# Service Bulletin

**SUBJECT:** Service Update for Inventory and Customer Vehicles  
OnStar® Cable Interference  
Expires with Base Warranty

**MODELS:** 2015 Chevrolet Equinox  
2015 GMC Terrain  
Equipped with Front Electronic Control HVAC System (C67/C68)

Subject: 14682 – Service Update Bulletin  
OnStar® Cable Interference

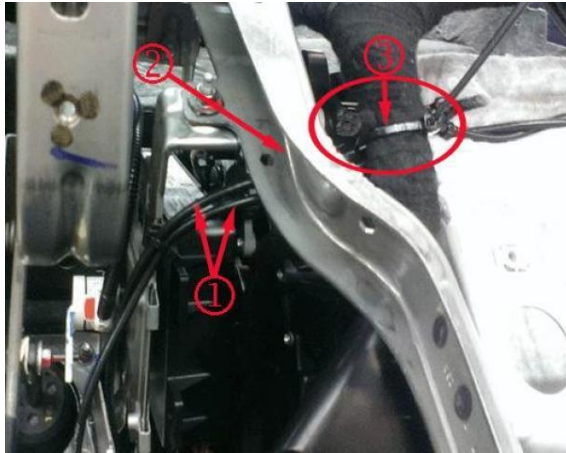
**Note:** Tie strap both OnStar cables to the IP harness away from the HVAC mode door following the procedure below. The procedure can be done with the instrument panel in the vehicle.

3. Take both OnStar cables (1) and pull away from the HVAC mode door while routing under the instrument panel support (2) and tie strap them to the instrument panel harness (3).
4. Reinstall the driver knee bolster reinforcement. Refer to *Driver Knee Bolster Reinforcement Replacement* in SI.
5. Reinstall the instrument panel insulator panel. Refer to *Instrument Panel Insulator Panel Replacement* in SI.
6. Re-perform the HVAC system check to confirm that the HVAC system operation is fully functional as expected.
